**REQUEST FOR TENDER No. 25-013**

**Oceanside Place Arena Heat Recovery and Energy Upgrades**

**Addendum 4**

RFI Title: Tender Question Responses

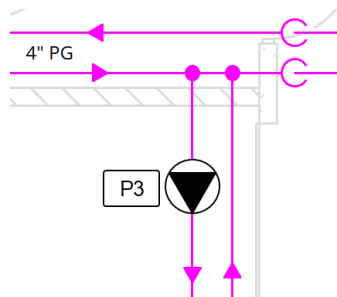
*The pump schedule has pumps 1 – 4 but the DH-1 loop has a p5.*

The Pump Schedule and Detail 1 on Drawing M4 are correct. P5 on Drawing M1 should be P3.
